Notification of Product Modification

Product Line:	Slim Jack	Part No:	NRJ6HM-1
Piece Part:	Nose and sleeve contact	Part No:	
Engineering Change Request:	E08-011	Date:	22.8.2008
Engineering Change Execution:		Date:	04.6.2009
Comments:	Development Request E08-011		
Affected products:	NRJ4HM-1, NRJ4HM-1-AU NRJ6HM-1, NRJ6HM-1-AU		
First shipment of modified Products:	NRJ6HM-1-AU NRJ6HM-1	second week of June, date code B24 middle of July, date code B30

Engineering Change Notice

Normalling circuit

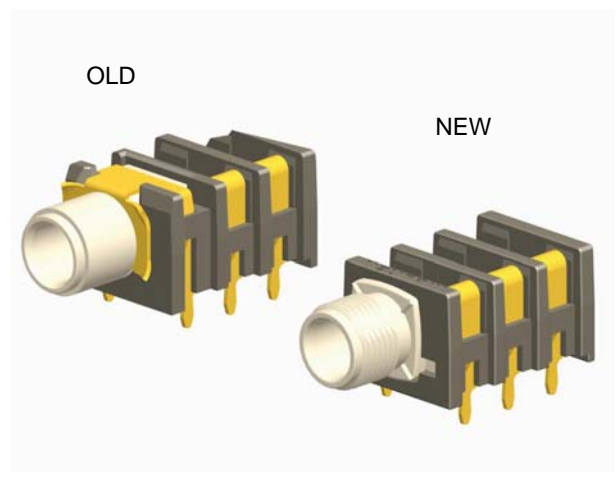
New spring loaded sleeve contact incorporating normalling function (SN contact).

Modified metal nose which makes permanent contact between nose (front plate) and sleeve contact (S). Front panel connection via ribs instead of bent barbs.

Changed material of nose from brass to zinc diecast ZnAl4Cu1, nickel plating remain the same.
